February 9, 1993
LD-93-016

Docket No. 52-002

SUBJECT: Revisions to CESSAR-DC Chapter 15 Safety Analyses Results

REVISIONS TO CESSAR-DC CHAPTER 15

SYS80+ : SLBFP post trip no LOOP
REACTIVITY

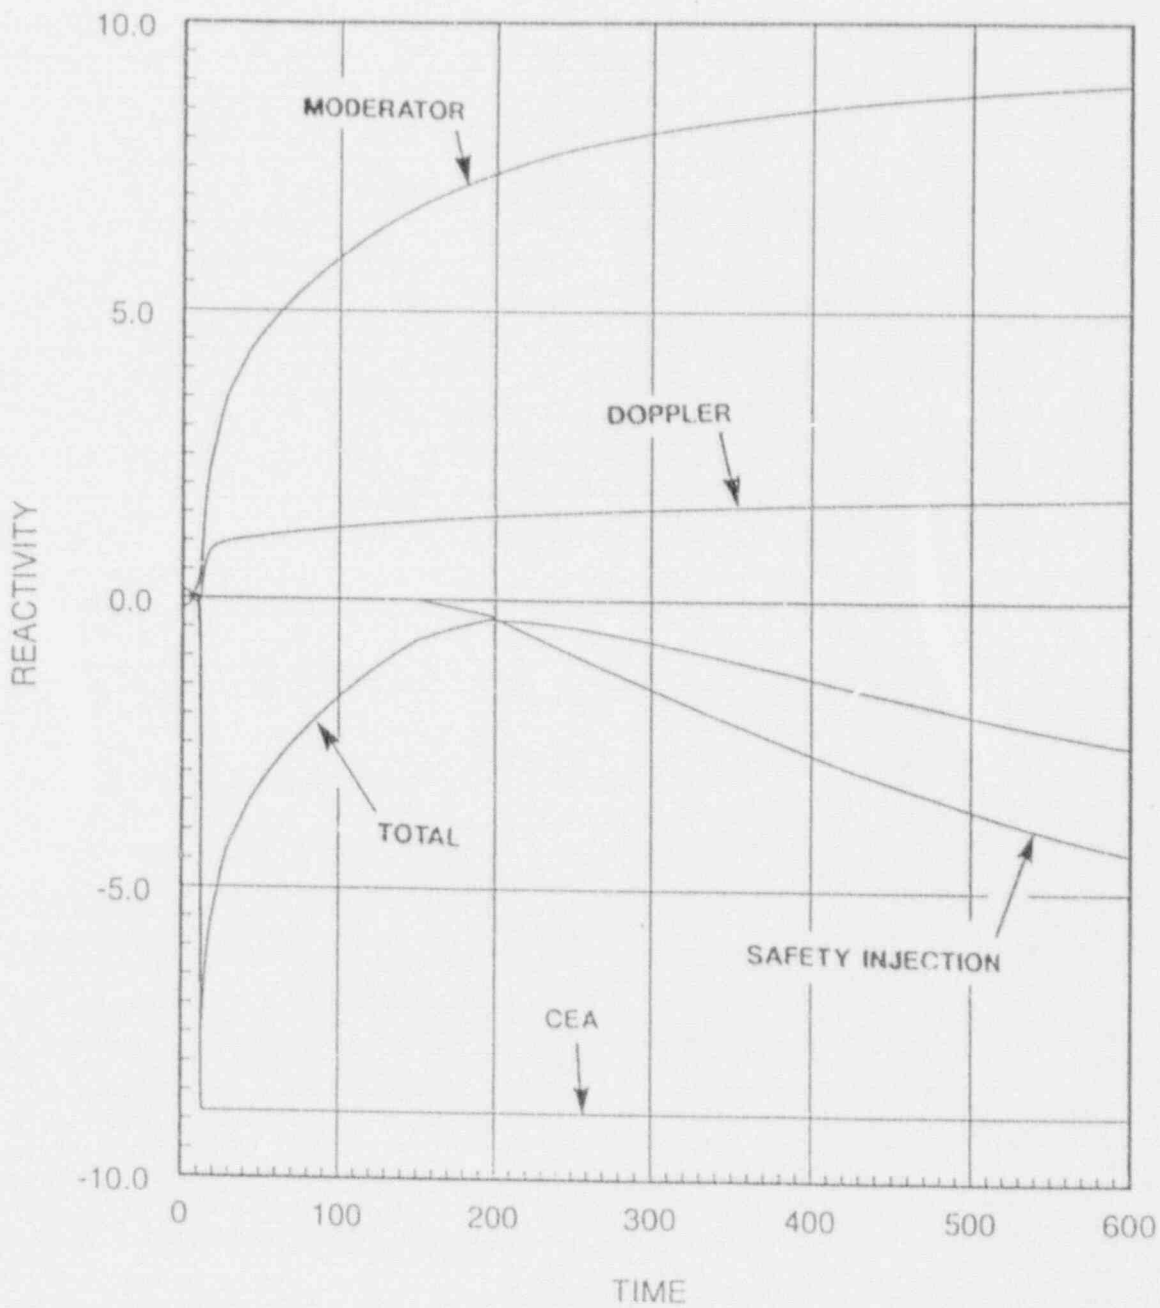
For case A. (SLBFP) the maximum post-trip core reactivity is -0.889 percent delta rho. There is no return to power, thus, the values of DNBR remain above those for which fuel damage would be indicated. The attached figure presents the transient reactivities for this event. The changes in the initial conditions and results due to the System 80+ power upgrade are shown in the attached mark-ups of Tables 12-1 and 2 (taken from the ABB-CENP response to Item 12 of NRC RAI 440.96).

Figure 15.2.8.1

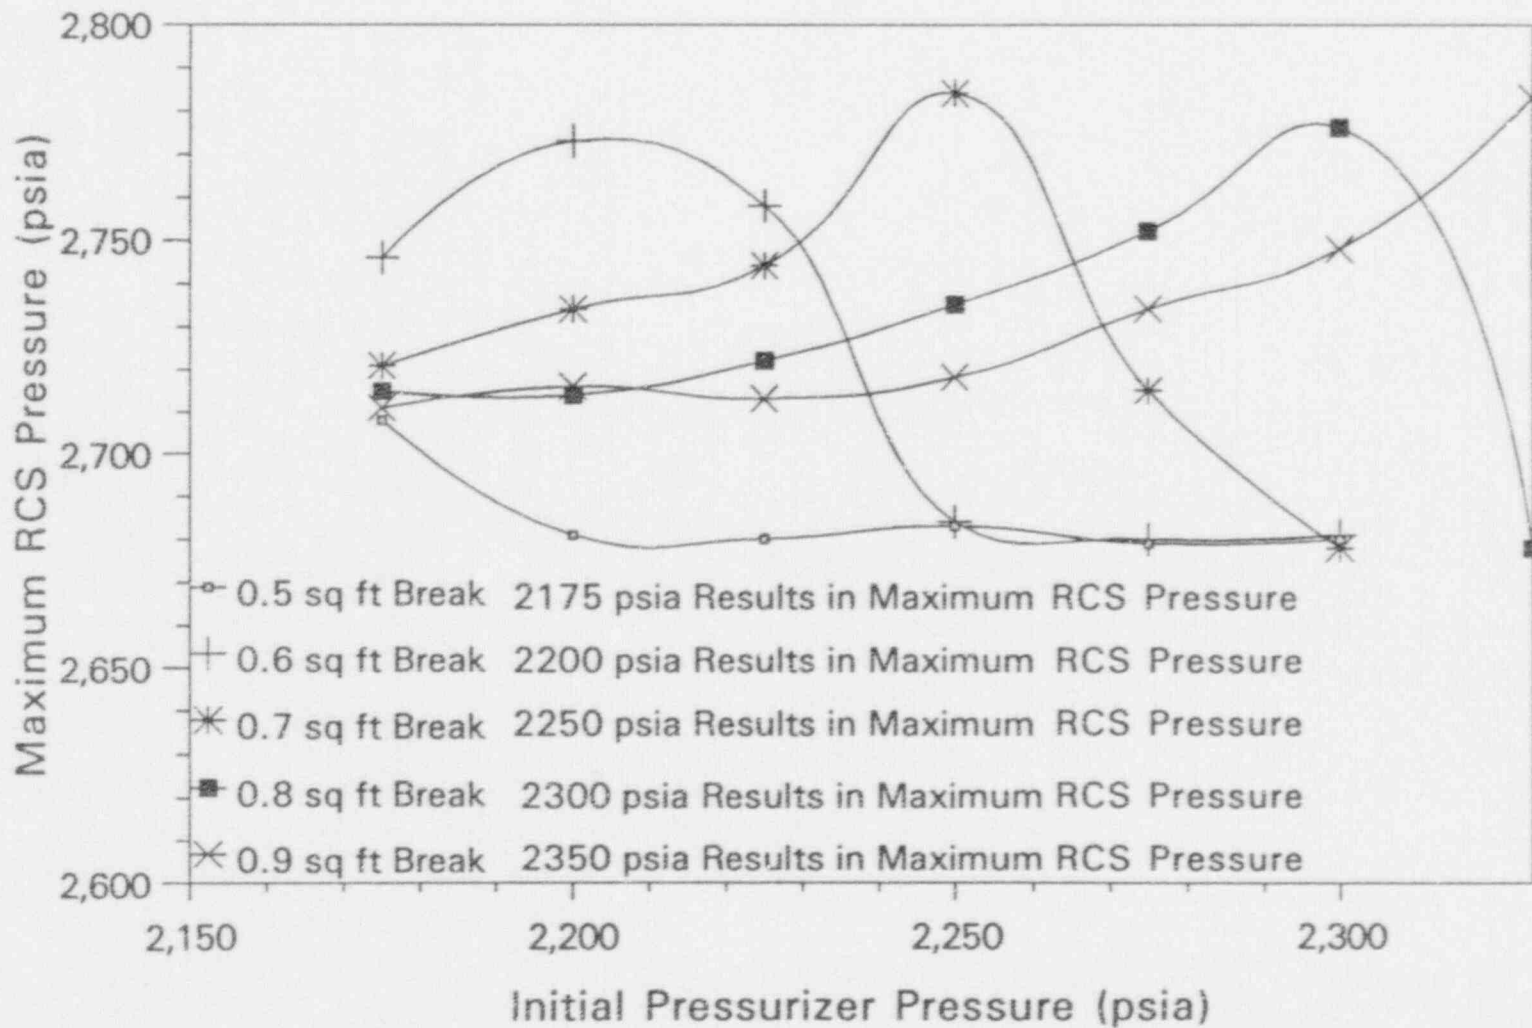
A parametric study covering break size and initial pressurizer pressure was performed. Figure 15.2.8-1 shows the maximum RCS pressure results for break sizes of 0.5 to 0.9 square feet as a function of initial operating pressurizer pressure. As can be seen for any given break size, there is a peak pressure for some initial pressurizer pressure. This is the initial pressure at which the affected steam generator dry out coincides with the pressurizer high pressure trip. If the initial pressurizer pressure is lower than that where the maximum transient peak pressure occurs the affected steam generator will dry out prior to the pressurizer high pressure trip, resulting in a lower pressure at the time of reactor trip. Similarly, if the initial pressure is higher than that where the maximum peak pressure occurs, the pressurizer high pressure setpoint is reached prior to affected steam generator dry out. This results in a lower peak pressure during the accident due to residual water inventory in

the ruptured steam generator providing greater heat removal after the trip, thus limiting the peak pressure. For all break sizes, when the initial pressurizer pressure is far from the initial pressure which results in the maximum transient peak pressure for that break size the peak pressure is approximately 2680 psia.

Figure 15.2.8.2

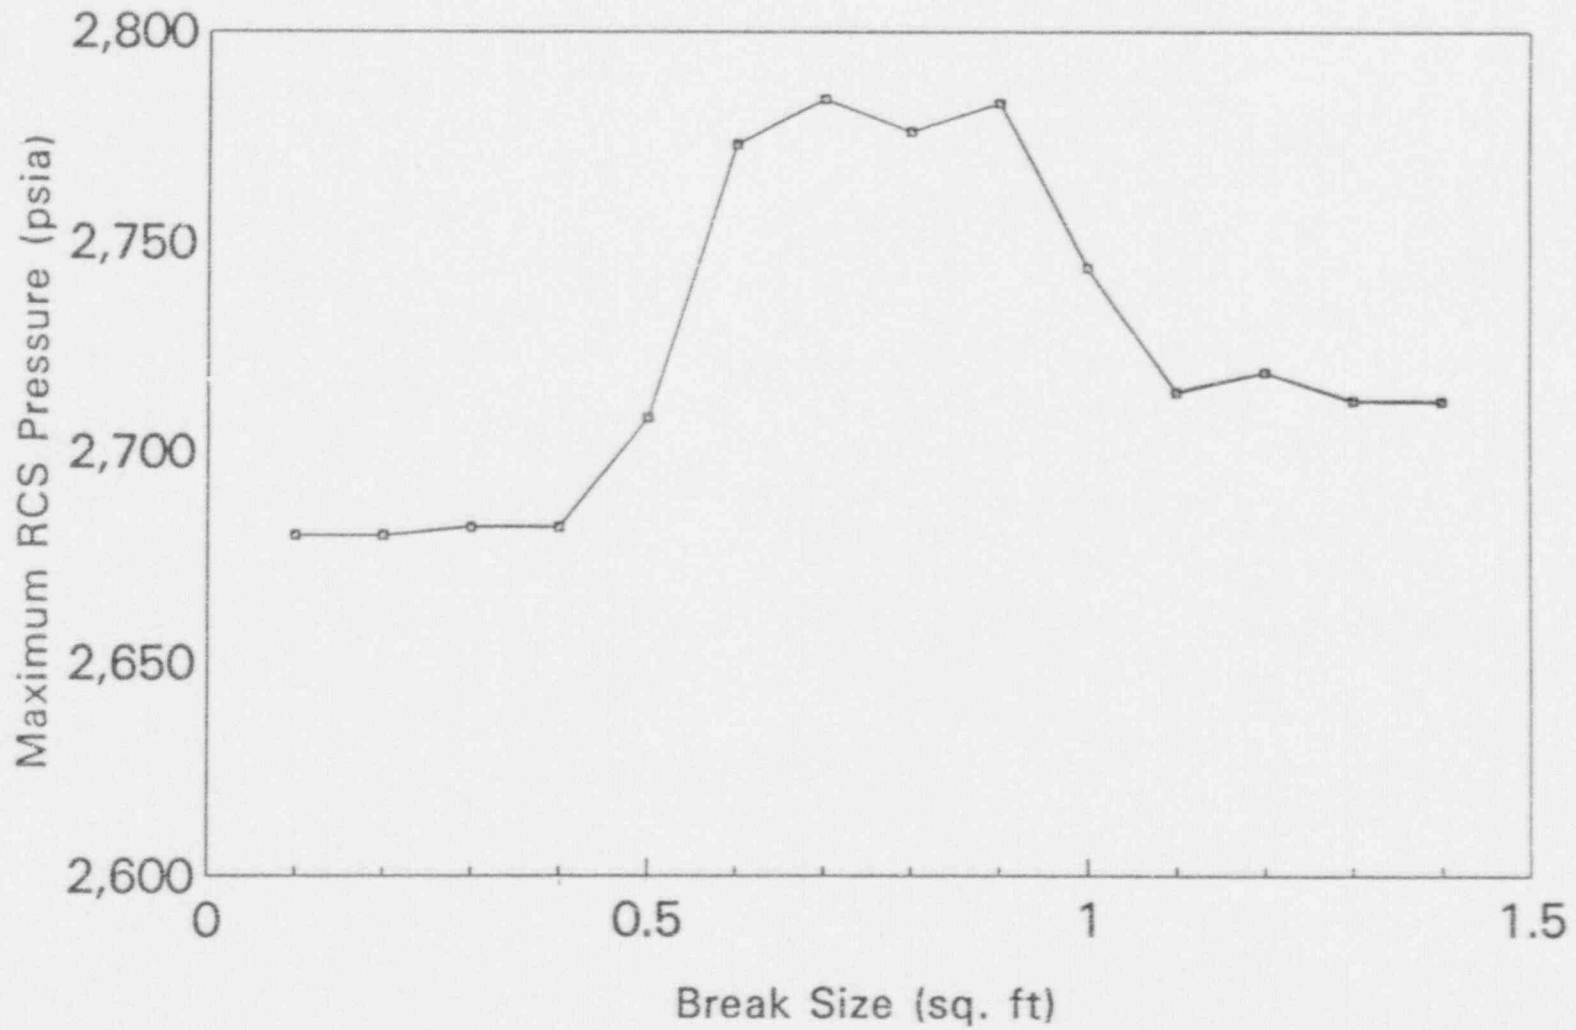
The maximum peak pressure achieved as a function of break size is shown in Figure 15.2.8-2. As can be seen for break sizes below 0.5 square feet, the peak pressure is well below 110% of the design as required for those breaks. The highest pressure reached is still within 120% of design pressure for large breaks.

FIG.15.3.3-11 SYSTEM 80+ SEIZED ROTOR LOOP 102%POWER

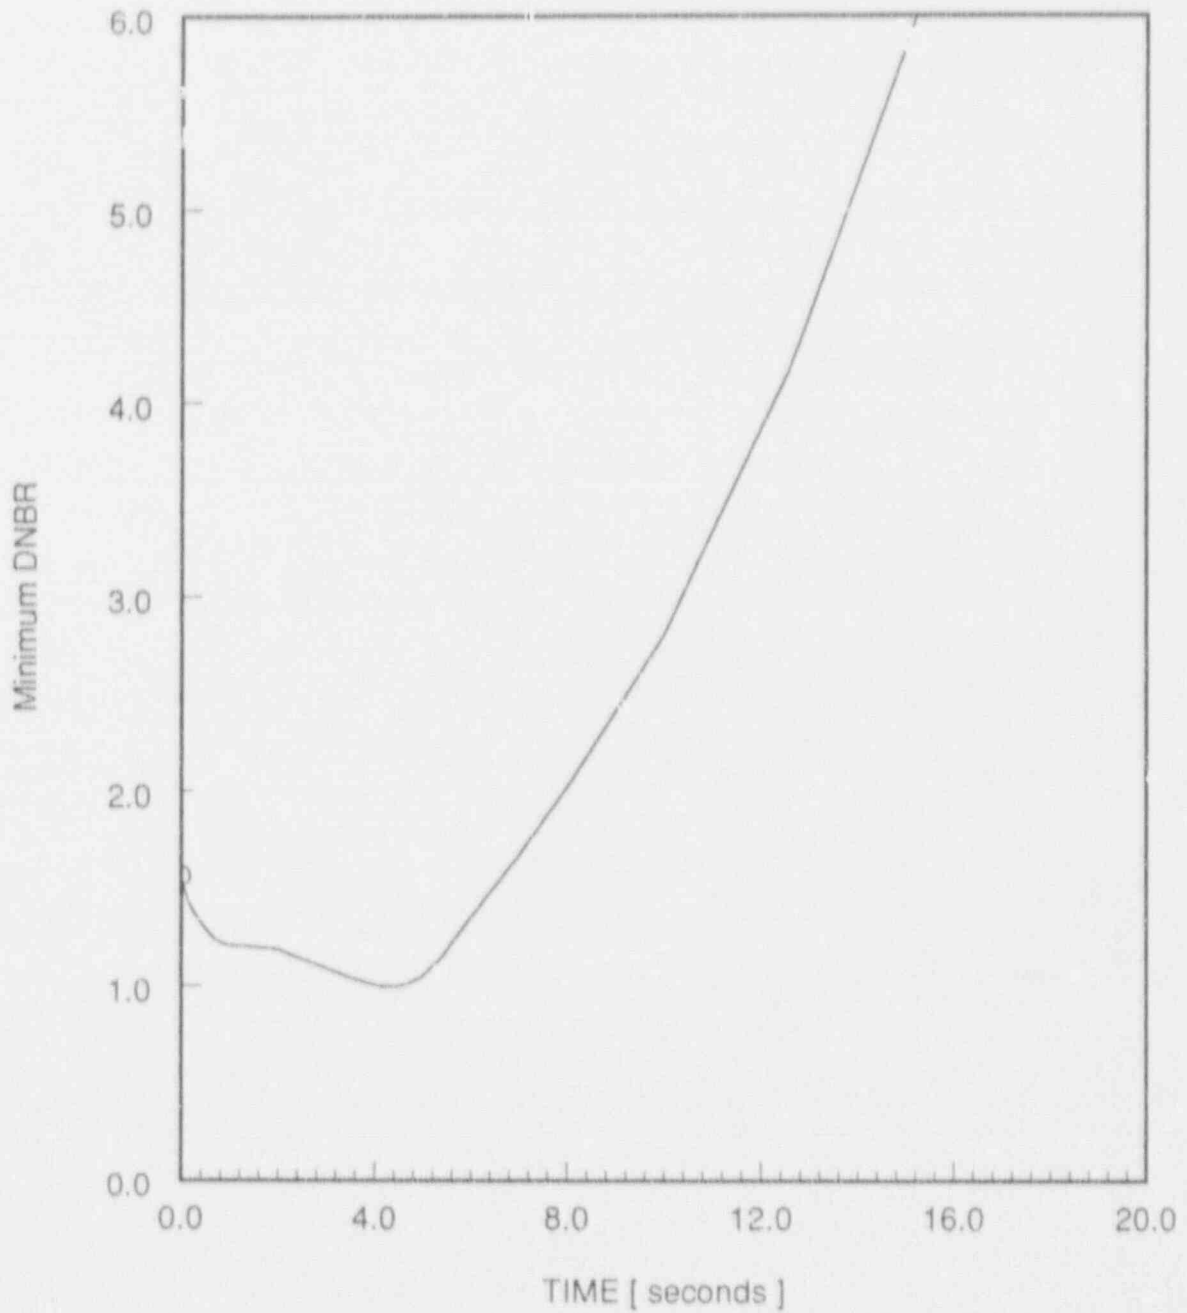
The minimum DNBR/fuel failure aspect of the analysis has been performed to demonstrate that the resultant offsite doses remain within 10CFR100 guidelines. The enclosed Figure 15.3.3-11 presents the minimum DNBR versus time for the most limiting initial conditions. It has been conservatively determined (based on the convolution method, Reference 1) that no more than 2.5 percent of the fuel should fail due to the RCP rotor seizure event with loss of offsite power coincident with the turbine trip. A brief summary of the results are presented below.
